## PRODUCT CHANGE NOTIFICATION

#PCN-DC-9VIT-12

Business Unit	Product Line Code	Type of Change	Action	Date of issue
DC	AAB	Mechanical	Notify Distributors and Field	11/19/2012

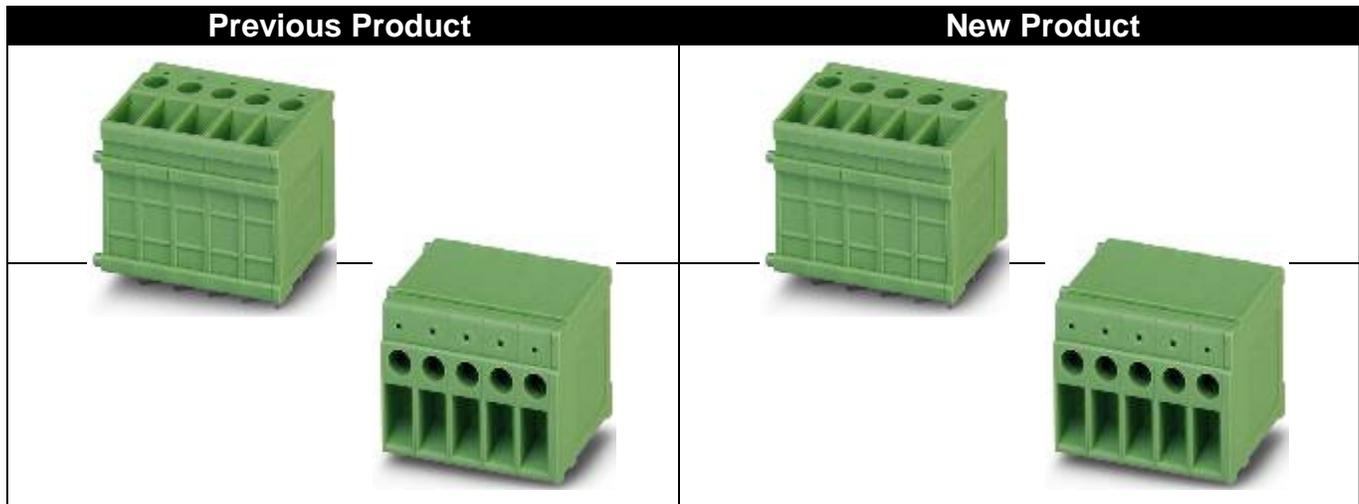
Due to our continuous improvement process, the mentioned articles will be changed to a different plastic material PA 6.6. Therefore, the inflammability class will improve from V2 to V0. All further dimensions and technical data will remain the same. During the conversion period both versions will be delivered depending on the inventory.
